Preliminary Roof Infrared Survey Report

Lynnwood Recreation Center
18900 44th Avenue West
Lynnwood, Washington

Ref: Preliminary Roof Infrared Survey
Lynnwood Recreation Center
18900 44th Avenue West
Lynnwood, WA

Detail 22/A5.4 from NAC architecture plans dated 12/11/2009 listing ceiling assembly under SIPs

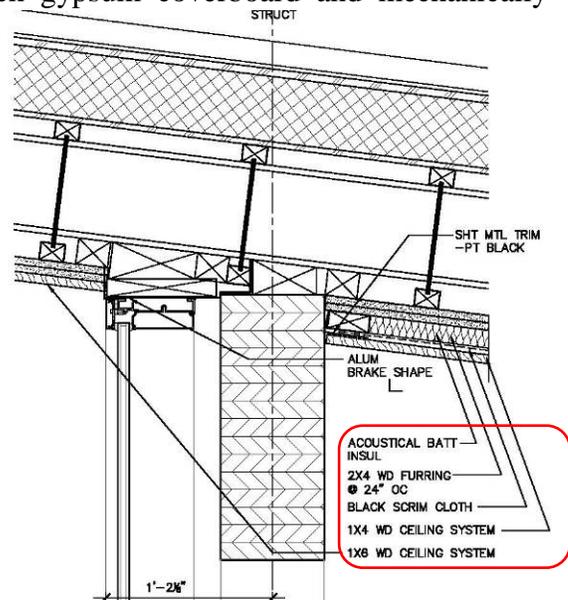
to the roof slope about 4 feet apart. It appears that this correlates with the edges of the SIPs panels which may indicate thermal bridging through the joints. Typically, SIPs connections are assembled with block or I-joist splines which are to be applied with continuous panel sealant on each side of the spline. In most cases, 6 inch SIP tape is specified on the (winter) warm side of the panel to prevent air and moisture infiltration into the assembly.

In regards to anomaly location 1, further intrusive investigation is required to determine how the SIPs connections were installed and confirm if a vapor barrier exists under the SIPs. Per Detail 22/A5.4 shown on Page 4, a 'black scrim cloth' is called out which would not provide a vapor barrier. There is a potential for condensation to occur at the Carlisle WIPHT self adhering underlayment due to warm and humid interior air migrating through the SIPs joints.

Considering the pool environment below, a continuous vapor barrier under the SIPs panels must be in place or moisture diffusion through the panels may result in condensation at the impervious roof underlayment over the panels, trapping moisture in the assembly.

Moisture Survey Roof Plan

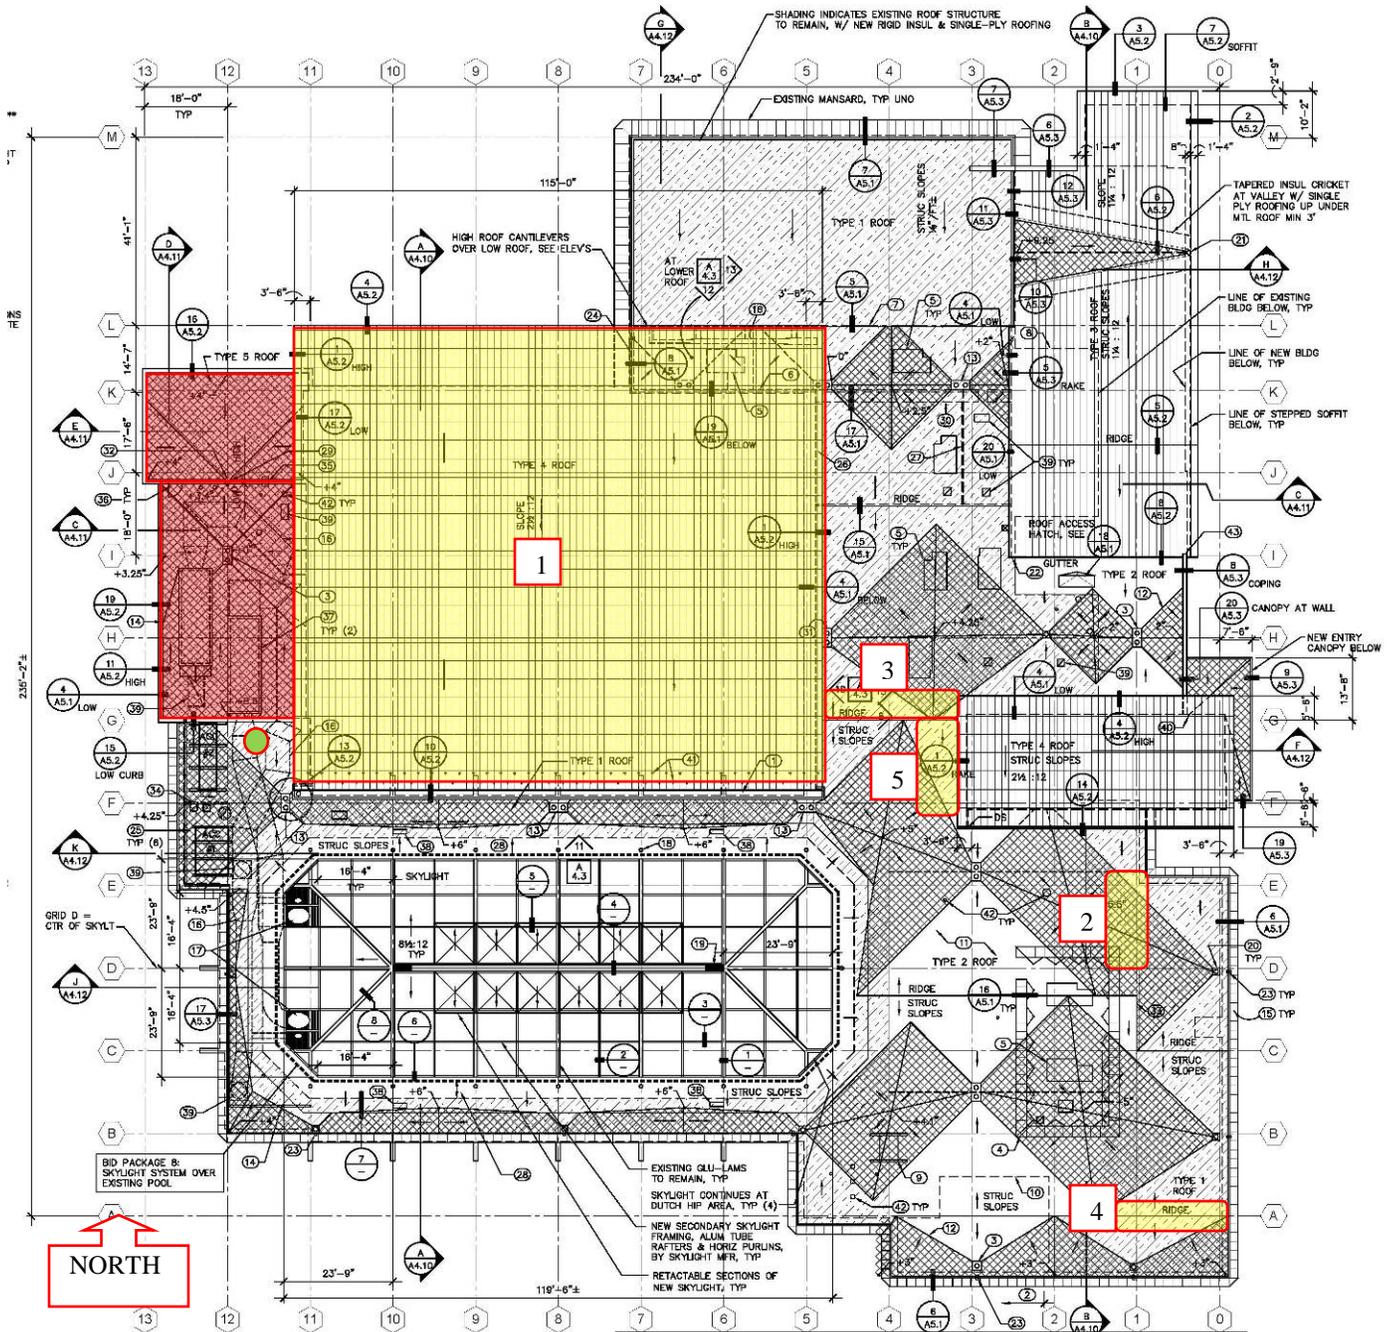
A roof plan denoting the approximate locations of the anomalies listed above is attached at the end of this report.

Photograph #1
Panoramic overview of main low sloped roof area as seen from the southeast.

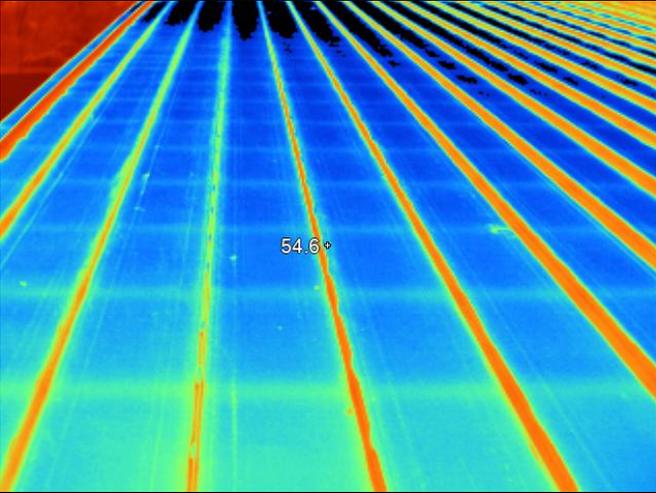
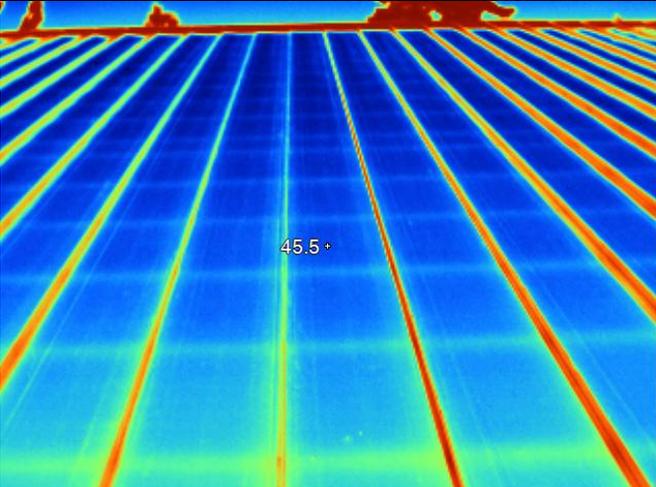
Photograph #2
Panoramic overview of west lower elevation roof where majority of current HVAC replacement work is scheduled, as seen from higher elevation roof to the north.

Photograph #3

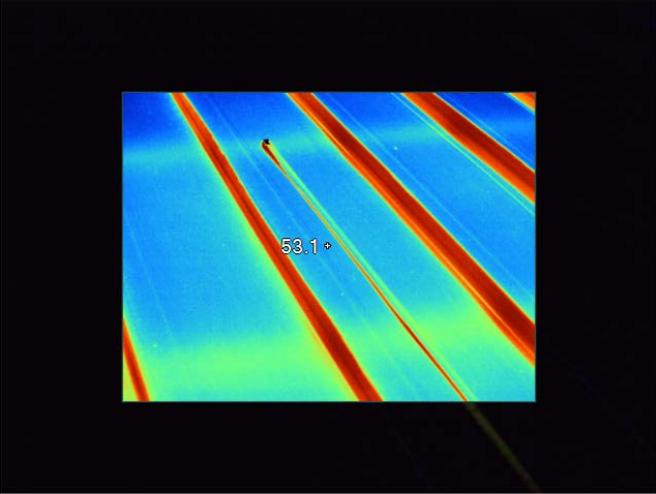
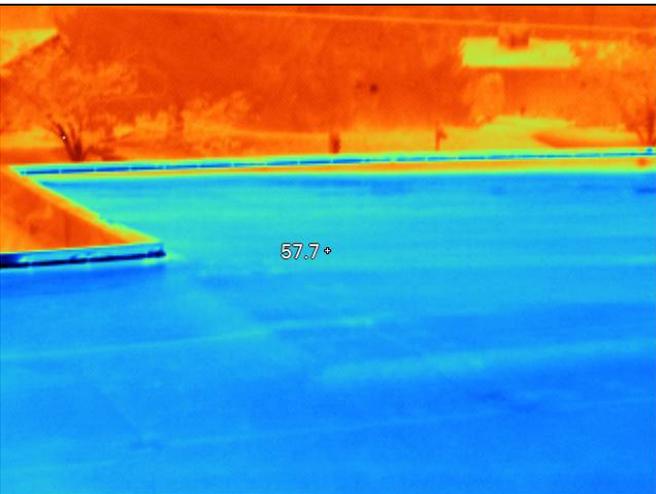
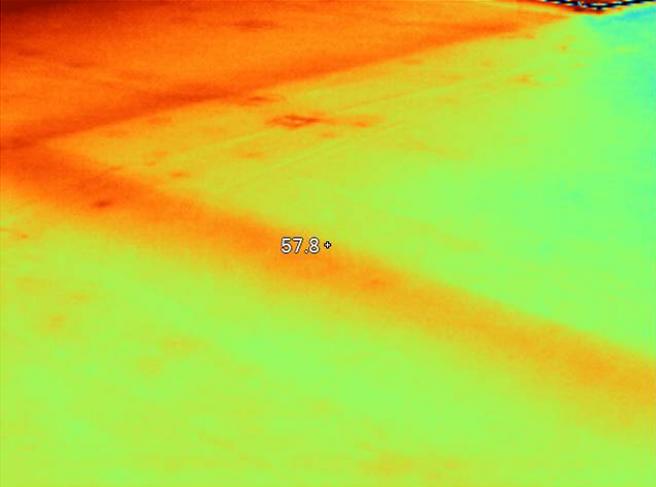
Near northwest corner of roof referenced on previous photo where initial roof demo occurred and halted due to discovering moisture in cover board.
